***Centre for Obesity, Diabetes and  
Cardiovascular Disease,  
The University of Sydney***

***MP09\_0051 MOD 1 – Modification to the  
design of the approved CODCD building***

Director-General's  
Environmental Assessment Report  
Section 75W of the  
*Environmental Planning and Assessment Act 1979*

**Figure 6:** *P*

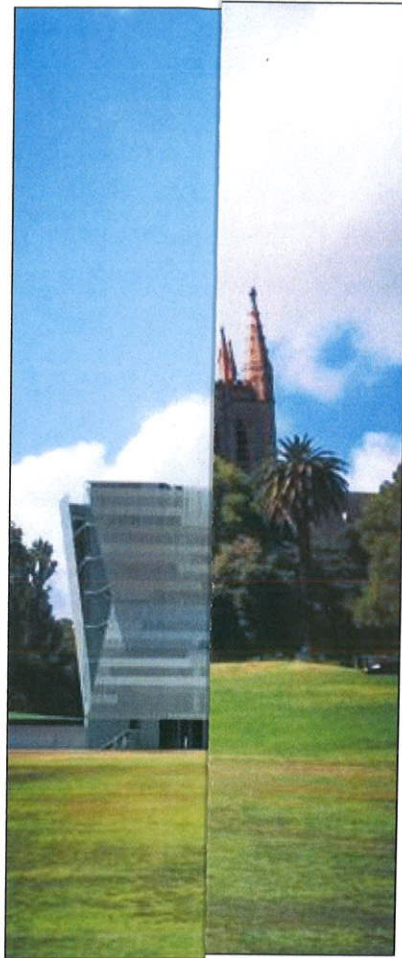
The modification includes the provision of a stair well on the north-west corner of the building and an auditorium on the north-east corner which results in a further encroachment on the alignment of 4 metres and 9 metres respectively. However, apart from a minor encroachment of the stairwell, the levels above the ground floor are further set back from that approved by approximately 1 metre. **Figures 9 and 10** show details of the ground and upper levels of the building.

The Department is satisfied that the further encroachment of the building beyond the projected alignment of the southernmost wall of St. Johns College does not result in additional impacts on the College building. A significant (60 metre) separation from the first point of encroachment is maintained whilst the curved façade addresses St. Johns Oval and maintains the major views to the College from Parramatta Road.

**Figure 8.** *Proposed upper level facade relationship to southern alignment of St. Johns College (Blue line indicates projected alignment of the southernmost wall of St. Johns College)*

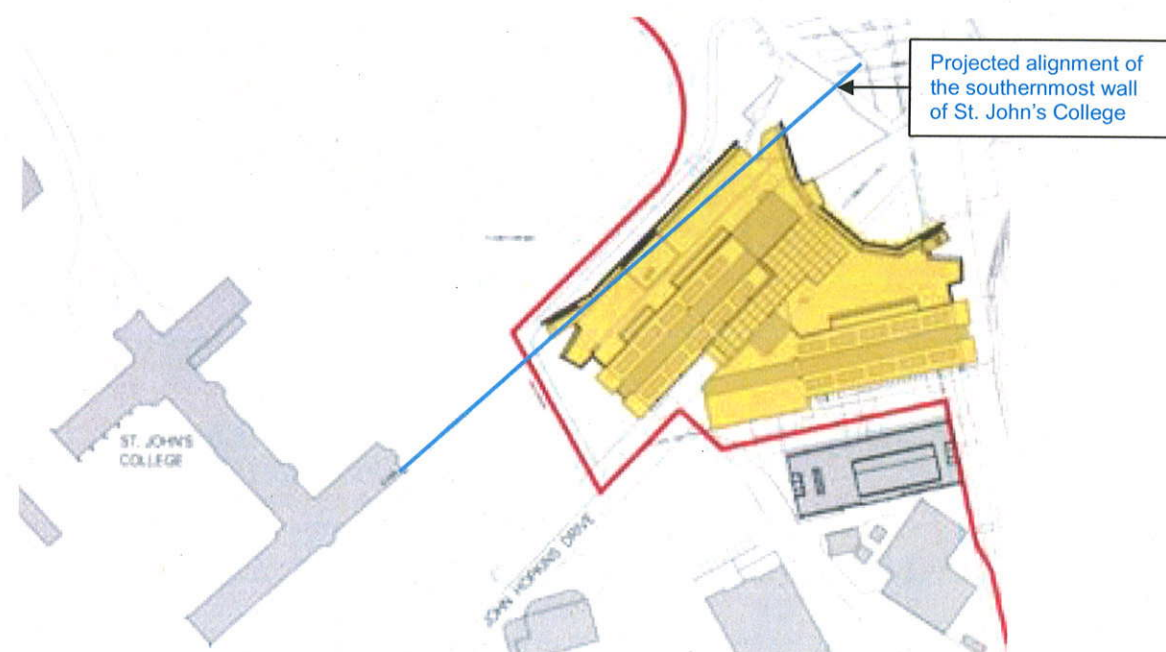
The two key components of the siting of the building relate to its separation from the St John's College building and to any northerly encroachment on the view line of the College defined by a line projected from the southernmost wall of the College as indicated in **Figure 8**.

Council had made a submission to the original application that the building should be contained so that it did not extend beyond the alignment of the southernmost wall of St. Johns College.

The Proponent's heritage consultant, Graham Brooks and Associates, had provided a response to this issue, acknowledging that the building would be within the view arc of St. Johns College but considered that the variation would be minor and was considered acceptable. The north-east corner of the approved building encroaches approximately 6 metres beyond the projected alignment of the wall of St. Johns College.
